29 December 2023

ADDENDUM #1

VENTURA HARBOR VILLAGE 1559 and 1583 Spinnaker Drive Restroom Enhancements

TILE SCHEDULE

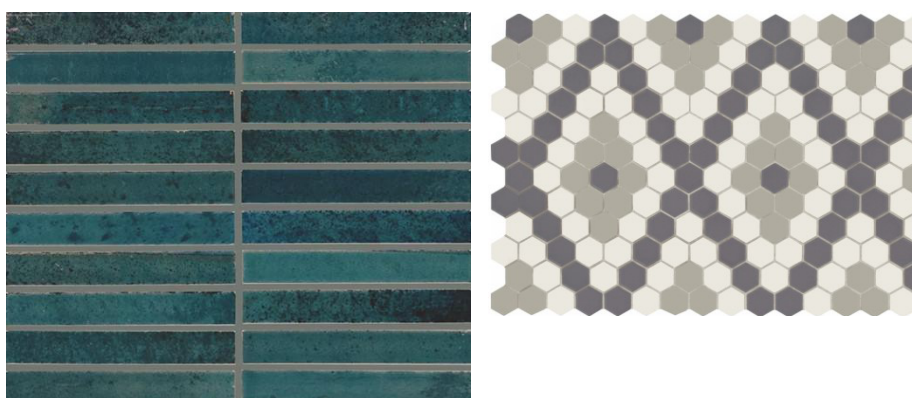
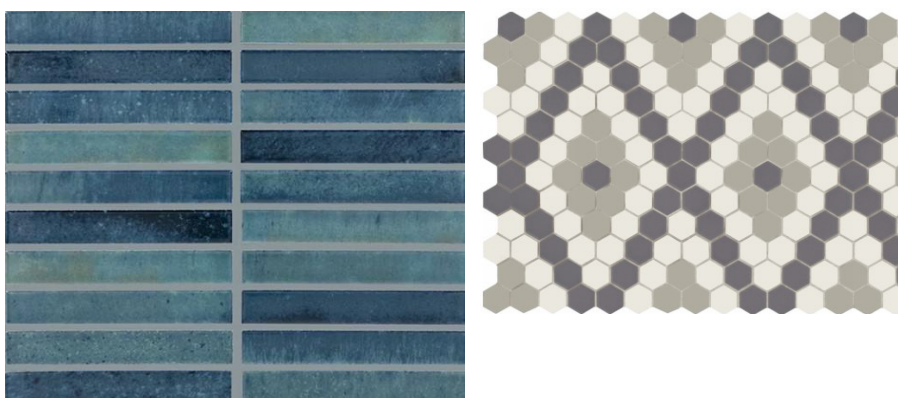
10. The floor tile for the men's and women's restrooms at 1559 and 1583 Spinnaker is AMERICAN OLEAN VINTAGE REVIVAL DIAMOND AO21; Colors: ICE WHITE, BLACK, LIGHT SMOKE. Please see attached revised sheet A4.1.

AMERICAN OLEAN VINTAGE REVIVAL DIAMOND A021; ICE WHITE, BLACK, LIGHT SMOKE

AMERICAN OLEAN VINTAGE REVIVAL DIAMOND A021; ICE WHITE, BLACK, LIGHT SMOKE

AMERICAN OLEAN VINTAGE REVIVAL DIAMOND A021; ICE WHITE, BLACK, LIGHT SMOKE

AMERICAN OLEAN VINTAGE REVIVAL DIAMOND A021; ICE WHITE, BLACK, LIGHT SMOKE
